Figure to Support Ballot Comment on IEC/IEEE P60802/D2.0

IEEE 802.1 TSN TG 2023.04.14

Correct Figure D.4/60802

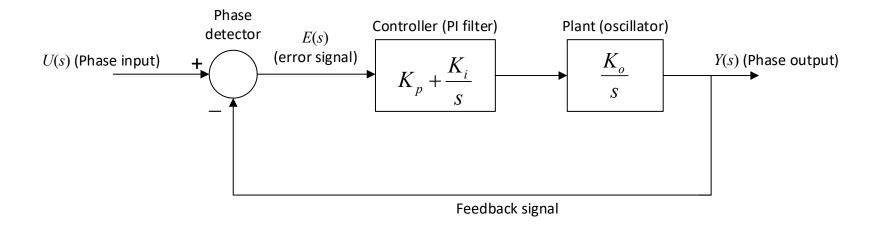
- □In reviewing P60802/D2.0 for the ballot currently in progress, it was notices that Figure D.1 is missing a number of labels
- ☐On checking with the editor, it appears that the labels were mistakenly removed when the word document was converted to PDF
- ☐ The author of this presentation is submitting a ballot comment on this
- ☐ To facilitate the comment, the correct figure is provided in the presentation on the next slide
